Office Action Summary

10/500,452

ZHOU, DANGSHENG

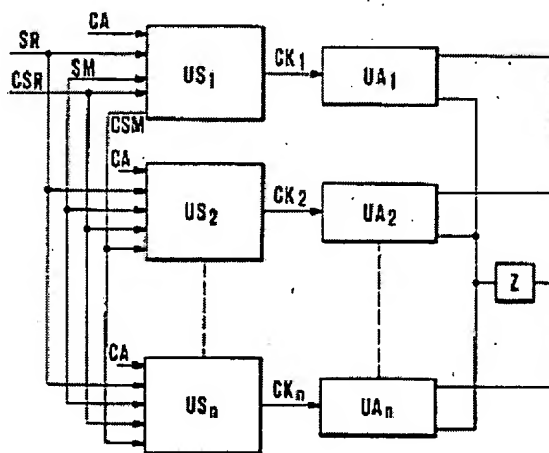
4. Claims 1-9 are rejected under 35 U.S.C. 102(b) as being clearly anticipated by Lentini et al. (USP 4,886,981). Lentini describes a synchronized circuit for a plurality of power units together if one unit is not synchronized with the other units possible damage could occur. See column 1 and 2- lines 1-51. See figure 1 below.
